[Docket No. FAA–2009–1253; Directorate Identifier 2009–NM–080–AD; Amendment 39–16629; AD 2011–06–05]

Airworthiness Directives; The Boeing Company Model 737–600, –700, –700C, –800, –900, and –900ER Series Airplanes

ACTION: Final rule.

Figure 1

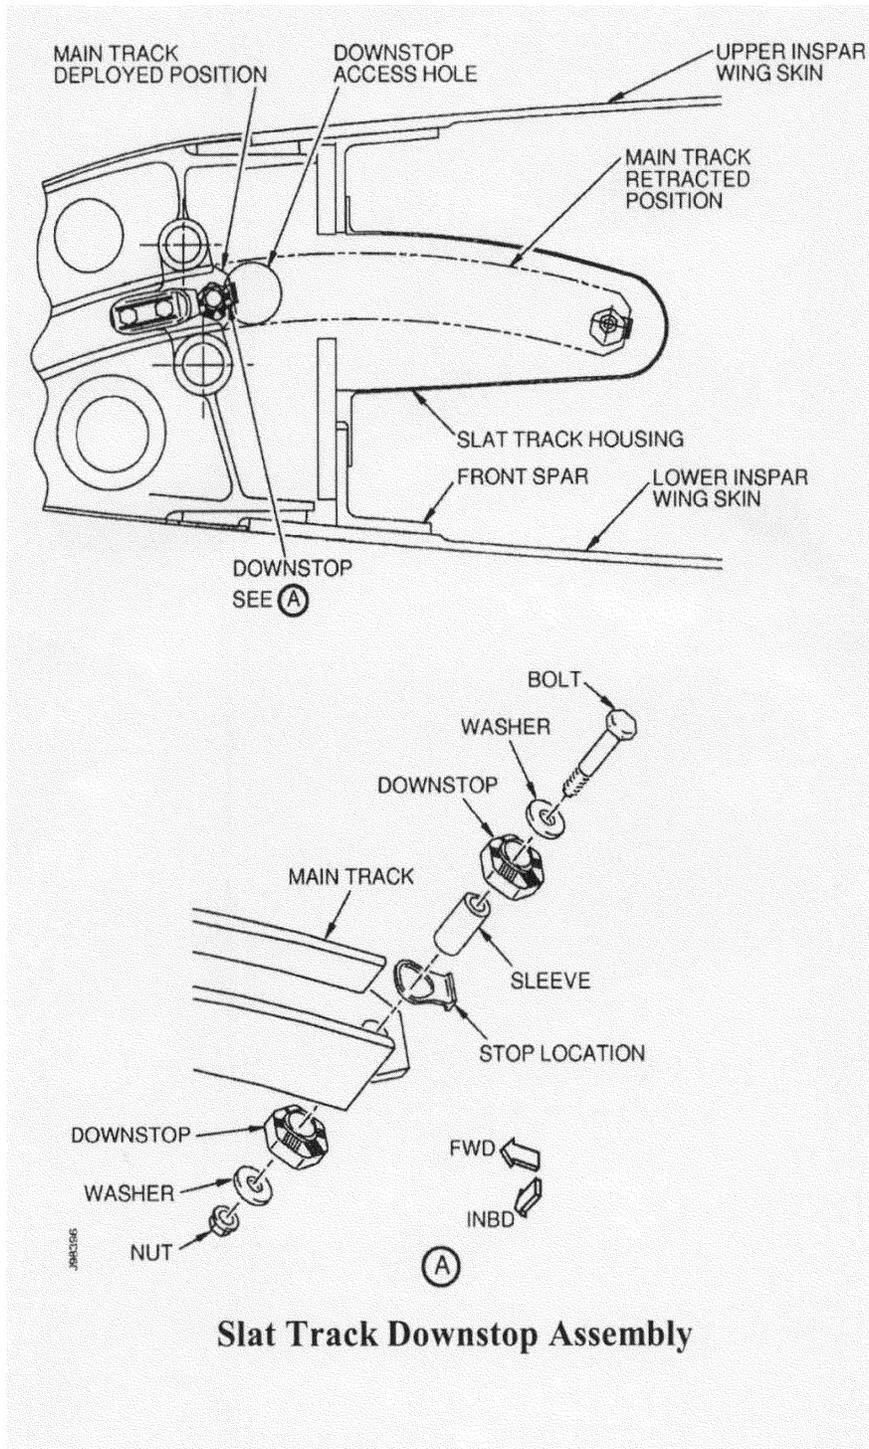
- (g) Within 10 days after September 26, 2007 (the effective date of AD 2007-18-52): Do a detailed inspection or a borescope inspection of each main slat track downstop assembly to verify proper installation of the slat track hardware (*i.e.*, the bolt, washers, downstops, stop location, and nut shown in Figure 1 of Boeing Service Letter 737-SL-57-084-B, dated July 10, 2007, and in this AD). Proper installation of the sleeve need not be confirmed, and the stop location part may be installed on either the inboard or the outboard side of the slat track. If any part is missing or is installed improperly, before further flight, install a new or serviceable part using a method approved in accordance with the procedures specified in paragraph (j) of this AD; and do a detailed inspection of the inside of the slat can for foreign object debris (FOD) and damage. Before further flight, remove any FOD found and repair any damage found using a method approved in accordance with the procedures specified in paragraph (j) of this AD. Verify proper installation; install a new or serviceable part; and inspect for damage and FOD, and remove FOD and repair damage; in accordance with a method by approved by the Manager, Seattle Aircraft Certification Office, FAA; or in accordance with Boeing Multi Operator Message Number 1-523812011-1, issued August 25, 2007, or 1-527463441-1, issued August 28, 2007. Repeat the actions required by paragraph (g) of this AD thereafter at intervals not to exceed 3,000 flight cycles.
